Engineers Comments Regarding Surface Water Drainage

Application Reference:	WA/106/24/DOC	Reviewer Reference:	ADC/EXT2/D2134/68
Planning Officer:	Kathryn Welch	Date of Review:	13.11.2025
Site Name:	Land East of Tye Lane Walberton		
Application Description:	Approval of details reserved by condition imposed under reference WA/124/23/S73 relating to condition number 23(b) - SuDS System , and condition number 25(b) - SuDS Maintenance Manual.		
Assessment Number:	2 Of 2

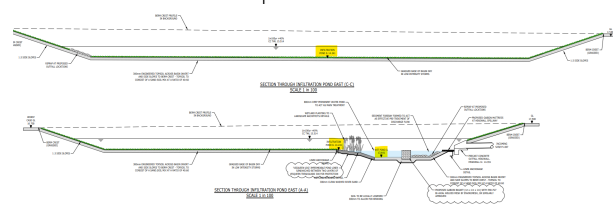
inspections have been completed for phase 2. Comment outstanding Designer Comments 1/04/2025 [WA/106/24/DOC] Added to section 5.7.				
	ADC Drainage Comments 03.08.2023 [WA/17/23/DOC – Full Site] The report should include an As Built survey to the requirements listed in ADC verification guidance note. It is recommended that the author reviews this list and arranges the revised report accordingly. ADC Drainage Comments 24/02/2025 [WA/106/24/DOC] Appendix D provides an as-built topographical survey however this only captures the swales and basins for phase 1. Comprehensive evidence for phase 2 is required. Evidence must be provided to ascertain if the FFL's for plots, roads and how they compare to the SUDS permeable pavement and to	Noted. The west basin design base was 12.01m and the as-built shows this to be 12.36-11.73m which matches or is deeper thus is accepted. The east basin design base however was 13.7m and the as-built shows this to be 14.25-14.49m therefore or not in accordance with the approved design and may provide insufficient storage. Please advise. Comment outstanding.	The As Built levels do reflect the basin design, please refer to cross section for the eastern basin in appendix B MAIN DRAINAGE CONSTRUCTION DETAILS (SHEET 3 OF 3)	The east basin as built shows slight variations in the overall footprint and base levels. The verification engineer must appraise the variations and if necessary show an overlay comparison. As previously noted are there any impacts to the storage? Comment outstanding.	Confirmation from Barter Hill in point 5.7 that phase 2 has been constructed in accordance with the approved drawings and is fit for purpose. The as built levels of the east basin provided by MK Surveys mirror the cross sections produced by Ardent. The majority of this basin is not designed to 13.7m as stated in comment, only the lowest section of basin which is how it has been constructed. Both snips below are from the report –

ensure no increase in flood risk. Designer Comments 1/04/2025 [WA/106/24/DOC] Added to appendix F.			
	ADC Drainage Comments 03.08.2023 [WA/17/23/DOC – Full Site] The report contains very limited evidence that all of the components of the drainage system as shown on the approved design drawings have been correctly installed, eg. Permeable paving, fin drains, catchpits, storm shark filter chamber. The only evidence is a single photograph of the cellular storage tank, part way through its construction, which does not provide sufficient evidence that the tank has been installed in accordance with the approved drawing. ADC Drainage Comments 24/02/2025 [WA/106/24/DOC] The verification report and supporting information does not meet the requirements of ADC verification guidance	Noted. Comment closed
